LS3P ASSOCIATES LTD.  
ADDENDUM NO. II  
January 20, 2012

# GATES COUNTY PUBLIC LIBRARY

GATESVILLE, NORTH CAROLINA  
P.N. # 8702-101650

ADD SPOT GRADES AND REVISE  
 GRADING AND DRAINAGE DITCH  
 SCALE: 1" = 30'  
 BD-C-03

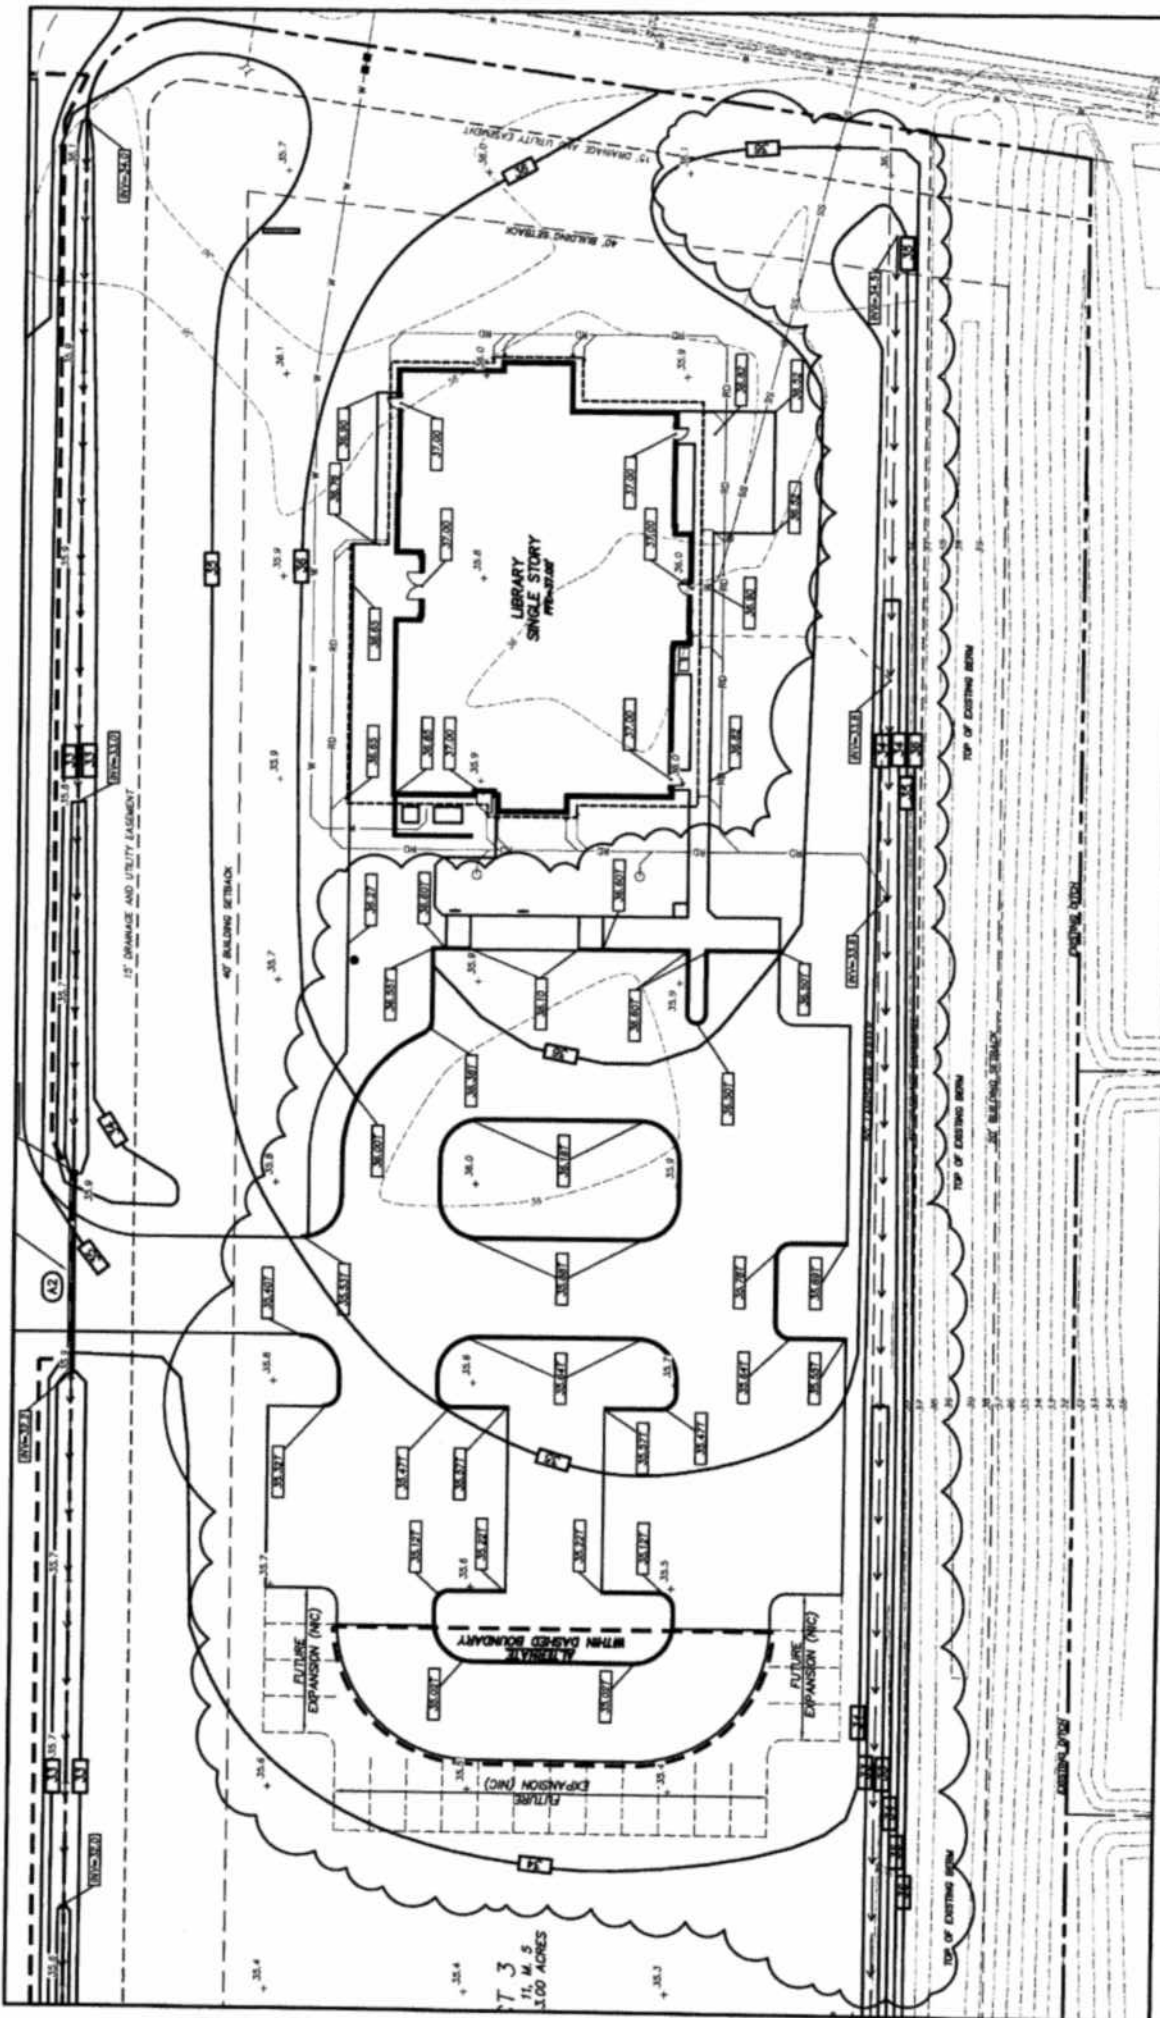
- A. Add additional proposed spot grades, Revise culvert, and Revise proposed grading and ditches to work with new existing contour data, as indicated on sketches BD-C-03 and BD-C-04.
- B. Revise the label: "Provide scheduled value of all work within the dashed boundary on the bid form. Also refer to other plan sheets for extent of work" to the following: "Provide the TOTAL COST of all work within the dashed boundary in the BASE BID BREAK-OUT PRICING SECTION on the bid form. Also refer to other plan sheets for extent of work AND INCLUDE THE COST FOR THAT WORK IN THE TOTAL"

REVISE EROSION CONTROL MEASURES  
 SCALE: 1" = 30'  
 BD-C-05

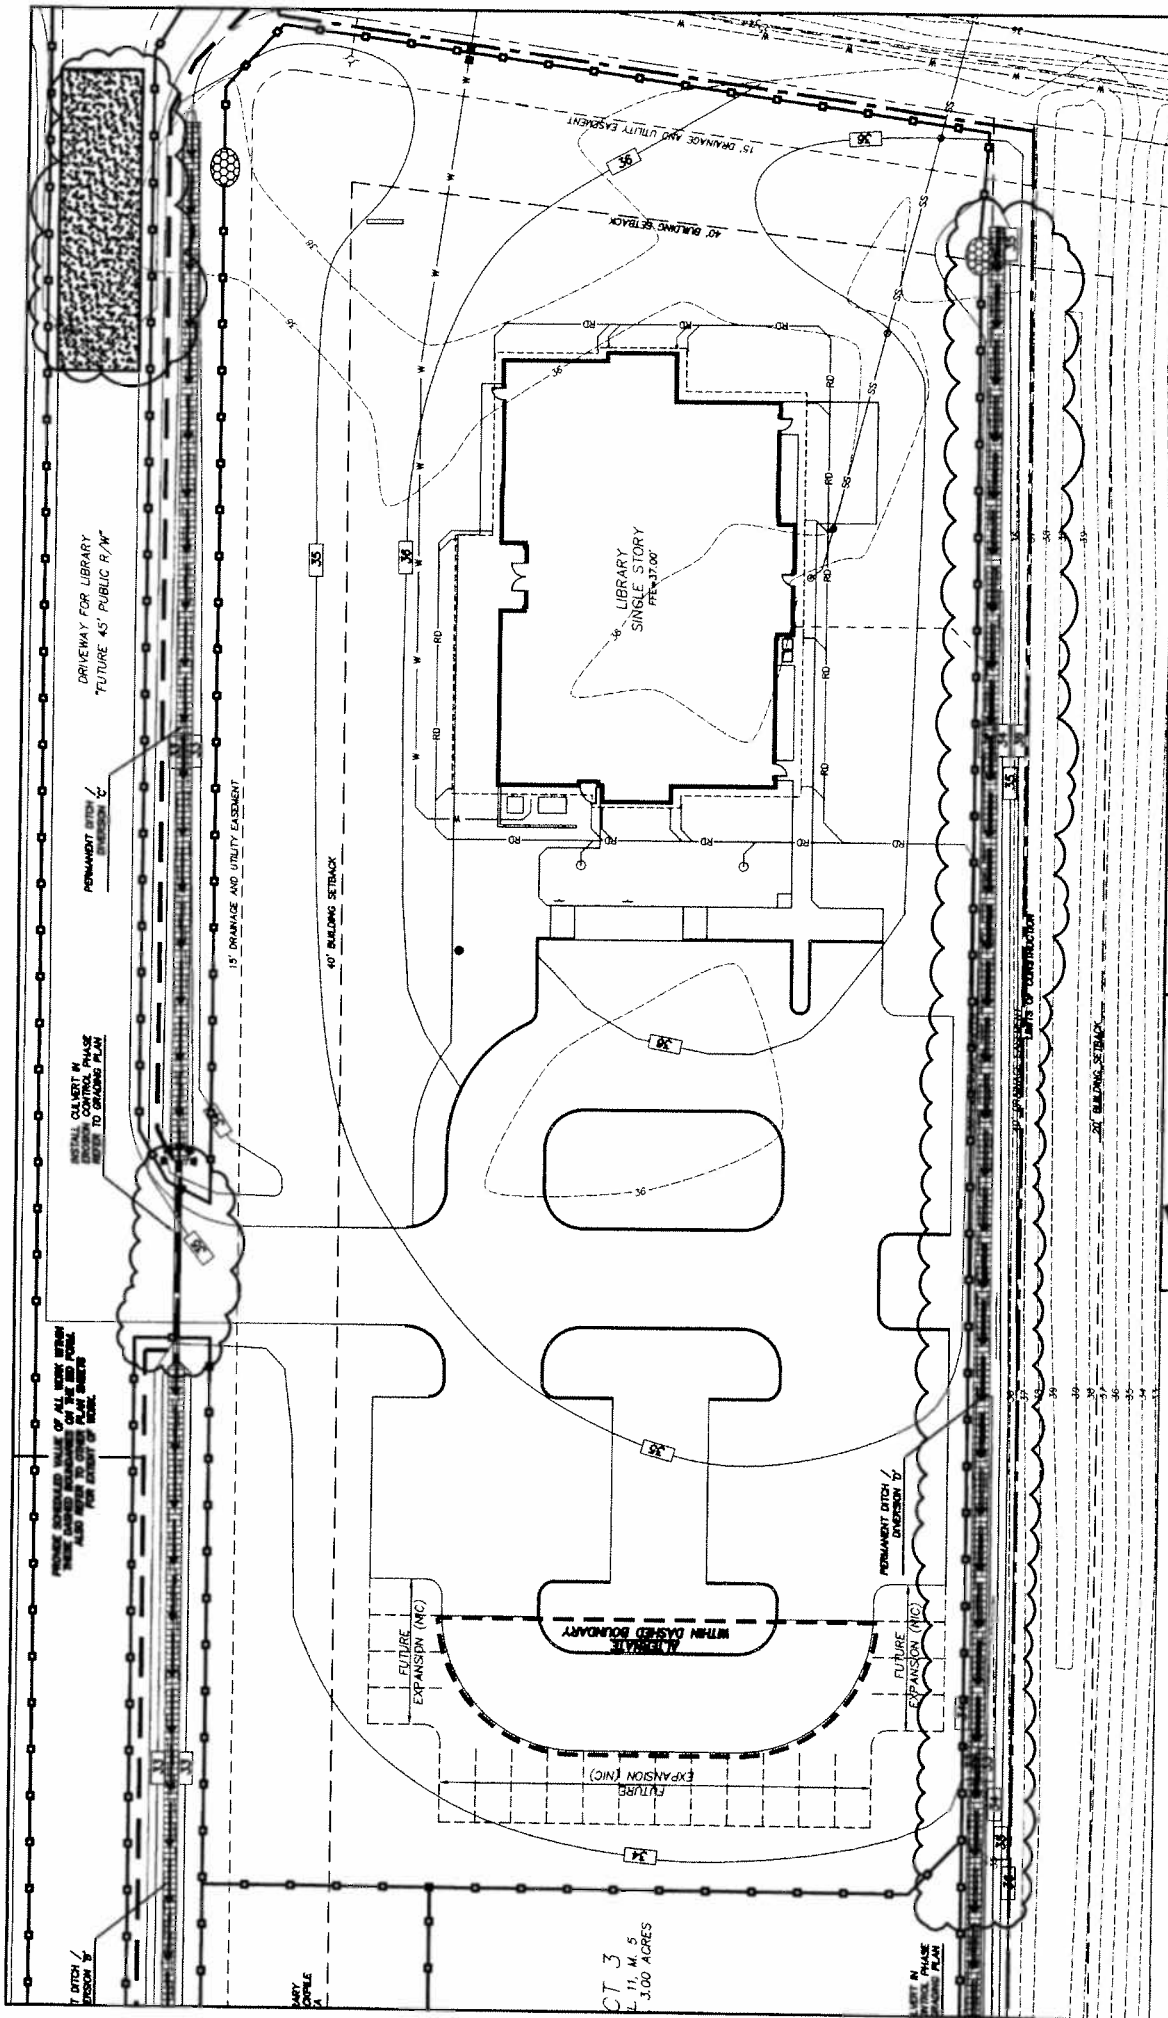
- A. Revise erosion control measures to work with new existing contour data and relocate construction entrance, as indicated on sketches BD-C-05 and BD-C-06.
- B. Revise the label: "Provide scheduled value of all work within the dashed boundary on the bid form. Also refer to other plan sheets for extent of work" to the following: "Provide the TOTAL COST of all work within the dashed boundary in the BASE BID BREAK-OUT PRICING SECTION on the bid form. Also refer to other plan sheets for extent of work AND INCLUDE THE COST FOR THAT WORK IN THE TOTAL"

BD-C-01

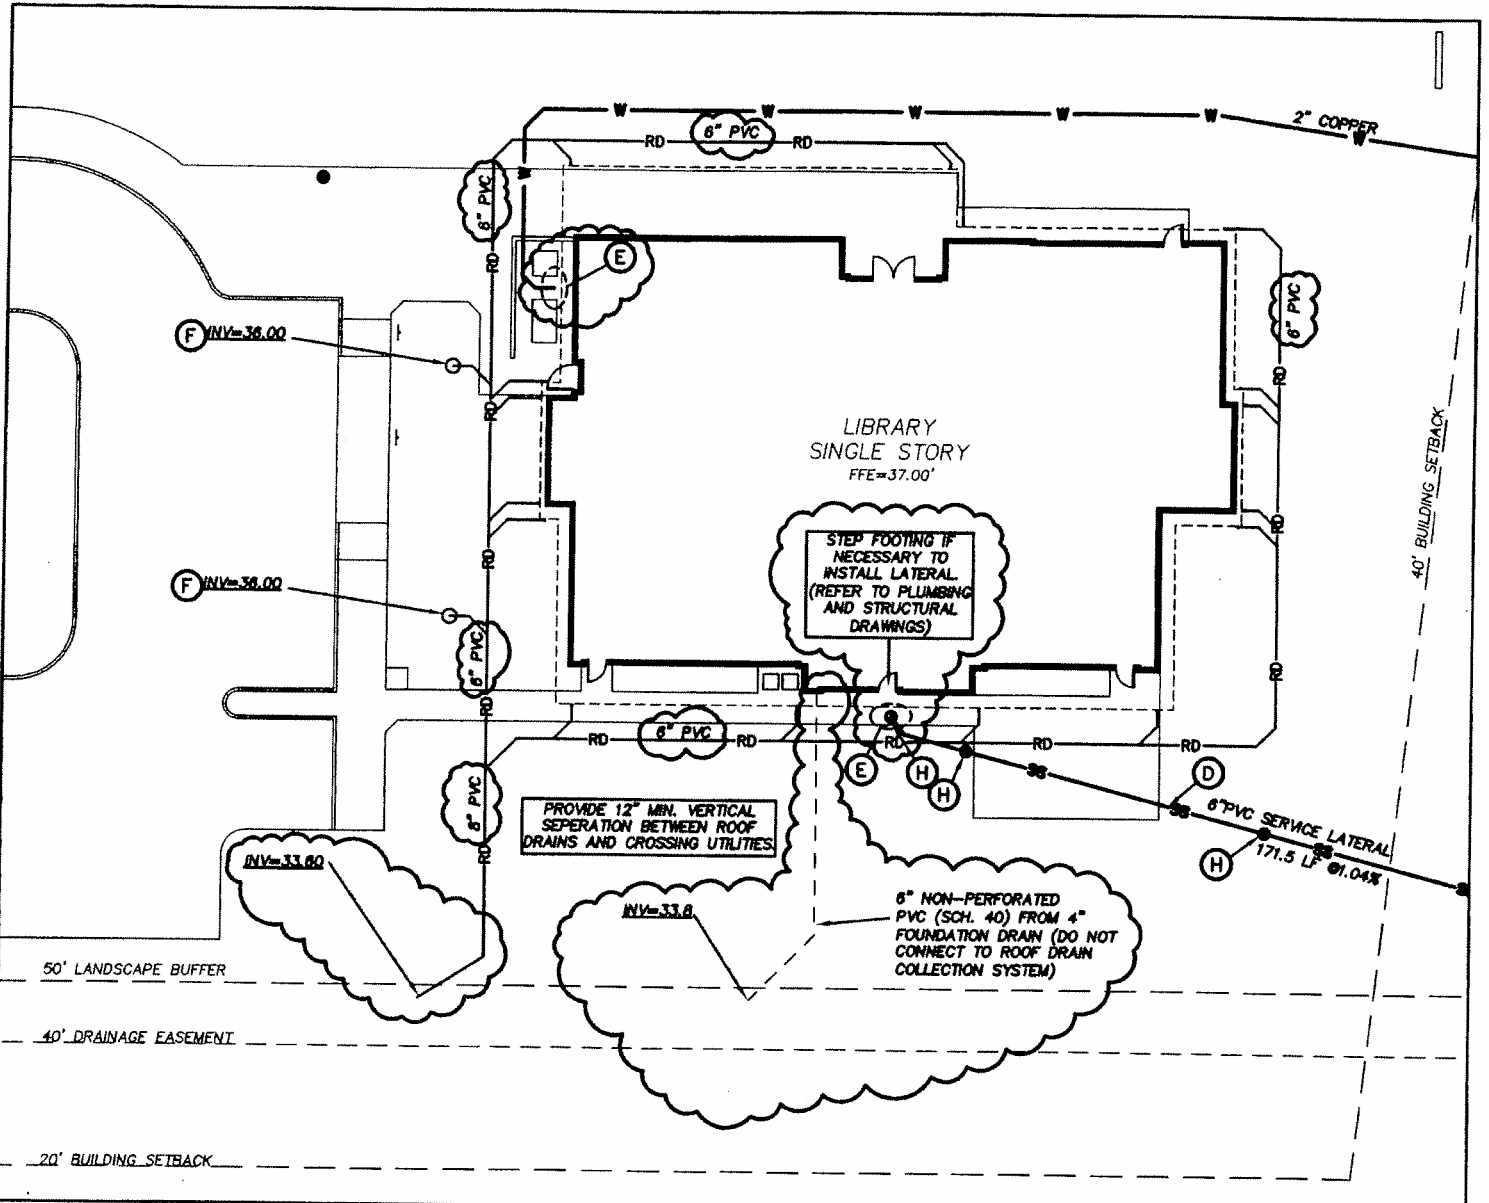
- A. Revise size of monument sign in plan view, as indicated on sketch BD-C-01.
- B. Add 42" x42" concrete sidewalk over 8" depth of ABC stone under this section of sidewalk, fasten bookbin (by owner) to the concrete sidewalk, as indicated on sketch BD-C-01.

- C. Revise label at trash bins to "7' x 5' Concrete Sidewalk for Trash and Recycling Bins. (Bins by Owner)", as indicated on sketch BD-C-01.
- D. Add screen walls (refer to architectural and structural), mechanical pads (refer to mechanical), and 6" depth of #57 clean stone over filter fabric in mechanical courtyard, as indicated on sketch BD-C-01.

<b>UTILITY &amp; DRAINAGE REVISIONS</b>
SCALE: 1" = 30'
<b>BD-C-02</b>

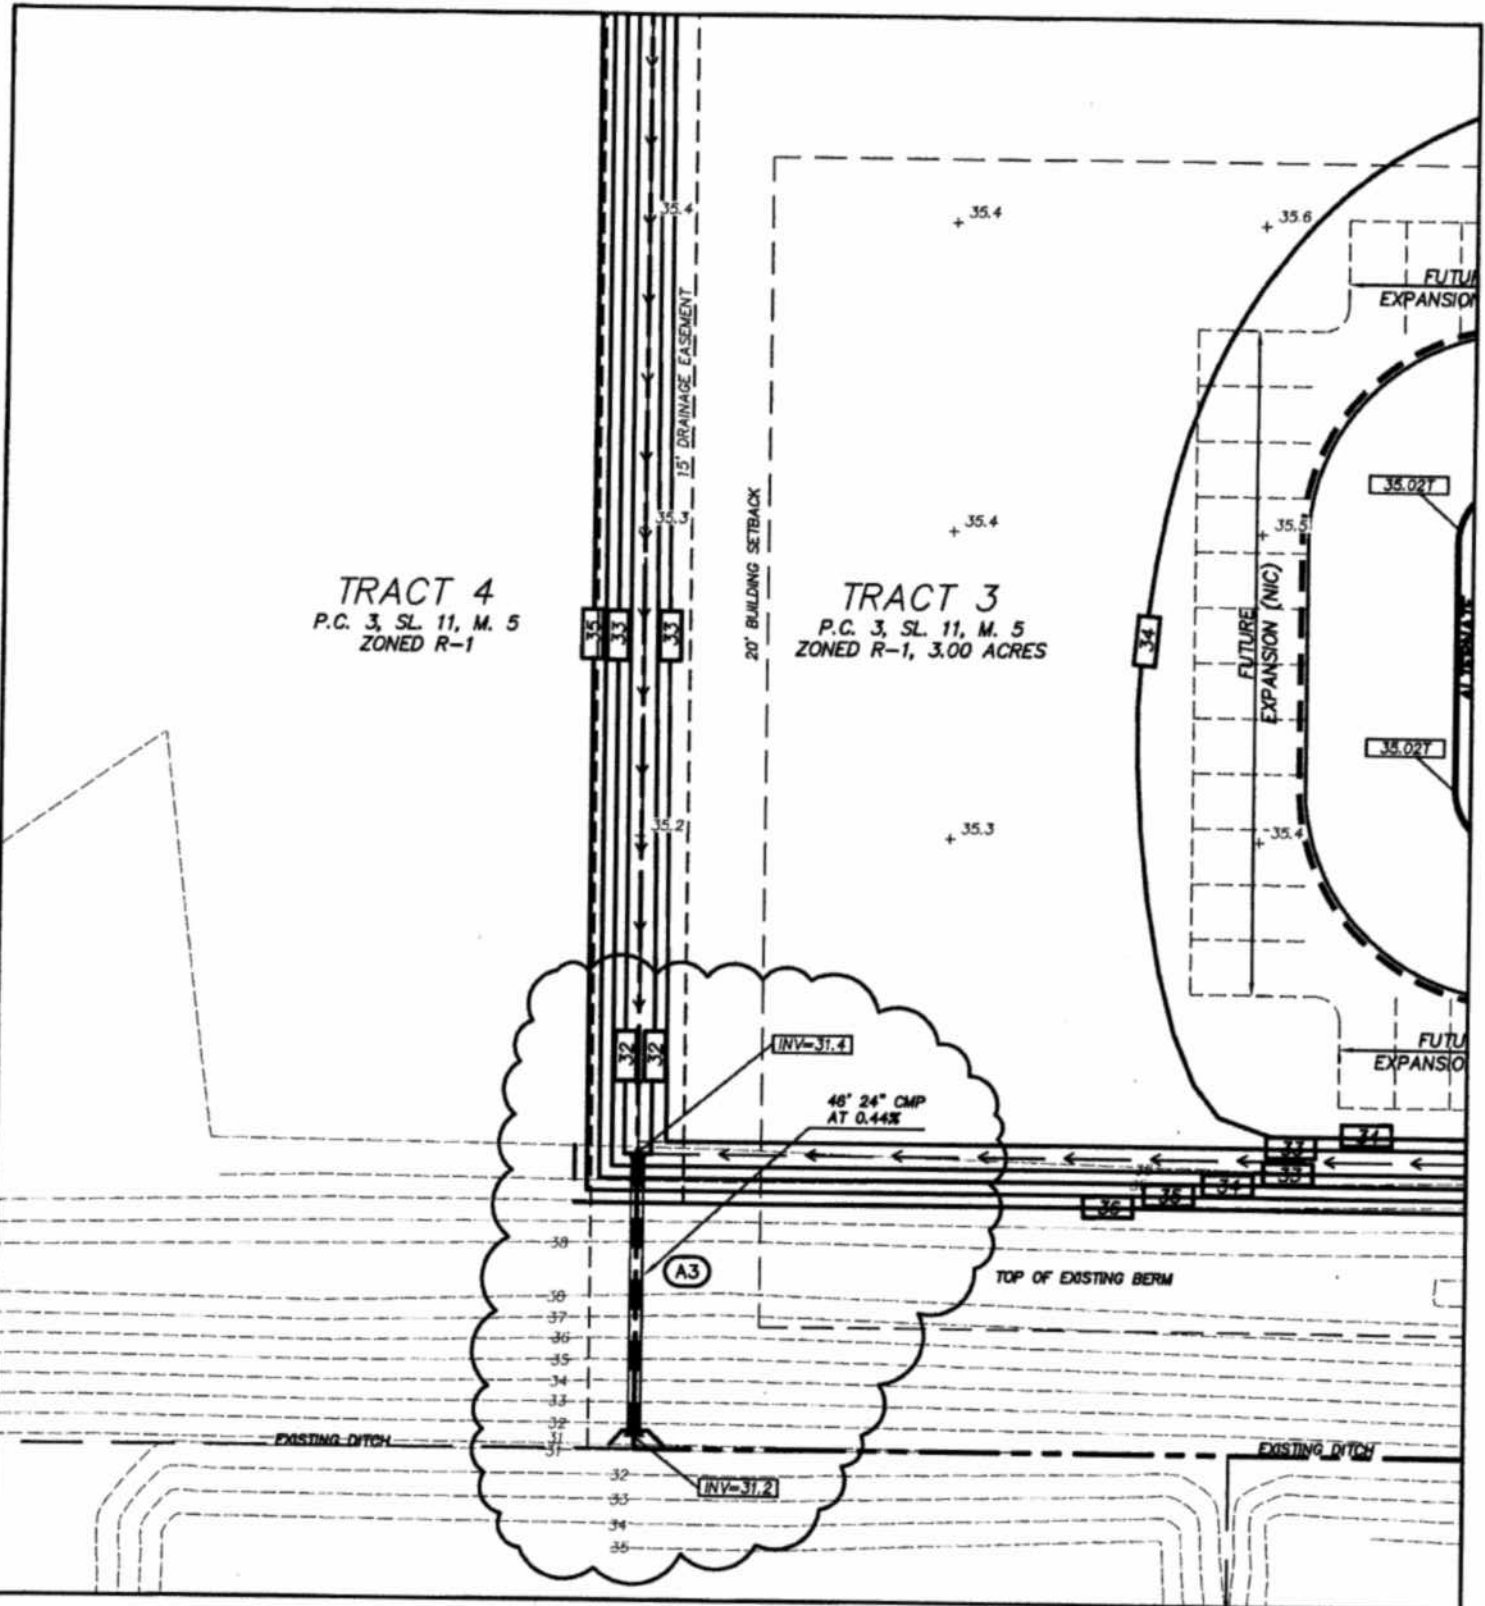
- A. Add 6" non-perforated PVC (schedule 40) drain pipe from 4" foundation drain (add fitting at size change), Revise location and invert of roof drain collector pipe, and Add roof drain collector pipe sizes, as indicated on sketch BD-C-02.
- B. Revise keynote "F" to "12 inch Inline Drain", as indicated on sketch BD-C-02.
- C. Revise location of domestic water and sewer lateral connections at building, as indicated on sketch BD-C-02.

Item II-12. Sheet C7.1. Revise keynote "F" to "12 inch Inline Drain", as indicated on sketch BD-C-02.
